SUBJECT: Recommendation from Planning Commission Sketch Plat for Structures of Diamondhead The Preserve Subdivision Phase 2

The Preserve PH 2 Sketch Plat

RE: Plan Review The Preserve PH 2 Sketch Plat

**FIGURE D103.1
DEAD-END FIRE APPARATUS ACCESS ROAD TURNAROUND**

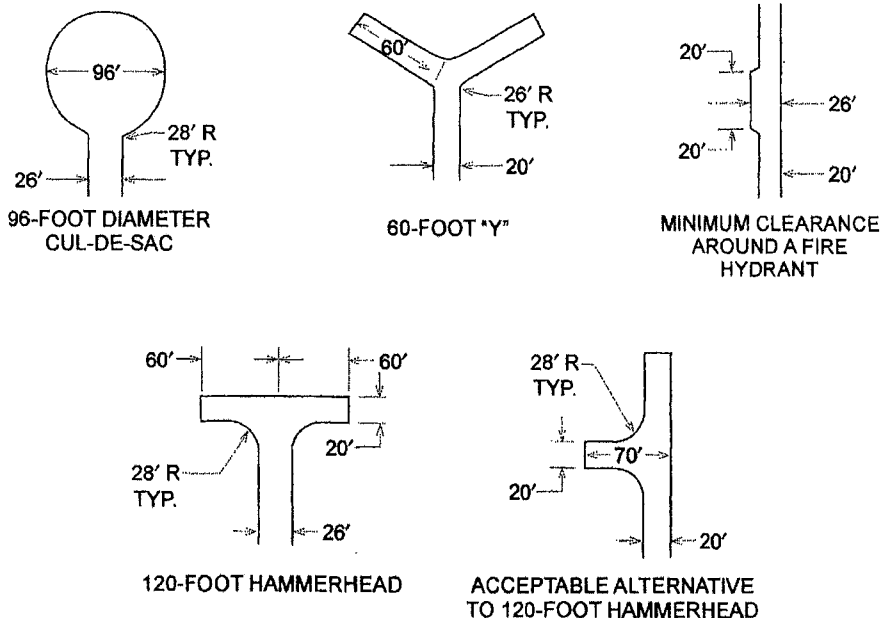
The Fire District's two main concerns with this project are access for fire apparatus and water supply. The reference material in evaluating these features is the International Fire Code 2012. Section 503 addresses Fire Apparatus Access Roads, the roads shall have an unobstructed width of not less than 20 feet and clearance of 13 feet 6 inches. I understand at this time there are only 25 plots shown for development and that falls under the requirement for dual access. The Fire District would like to make sure that we do not end up with a situation where that number is expanded past the 30 unit limit without a secondary access road or the buildings should be sprinklered. The other issue I could not evaluate from the sketch plan was the hydrant spacing and flow capability. Hydrants should not be more than 500' apart by road distance. This would be measured from the nearest hydrant on Diamondhead Drive West not the entrance to the development. The minimum flow requirements for hydrants, per section B105, is 1000 GPM for one and two family dwellings less than 3600 ft². Lastly, on access for turning around. The cul de sac needs to be at least 96 feet in diameter. The dead end either needs a temporary turn around, suitable for fire apparatus, until the street is finished through to Highpoint Dr or the bulge in the road near lots 2,3, and 4 needs to be large enough to allow our Ladder truck (36') to turn around in a "T" type maneuver (see attached graphic fig. D103.1). Thank you for keeping us in these discussions.

D103.4 Dead ends. Dead-end fire apparatus access roads in excess of 150 feet (45 720 mm) shall be provided with width and turnaround provisions in accordance with Table D103.4.

LENGTH (feet)	WIDTH (feet)	TURNAROUNDS REQUIRED
0-150	20	None required
151-500	20	120-foot Hammerhead, 60-foot "Y" or 96-foot diameter cul-de-sac in accordance with Figure D103.1
501-750	26	120-foot Hammerhead, 60-foot "Y" or 96-foot diameter cul-de-sac in accordance with Figure D103.1
Over 750	Special approval required
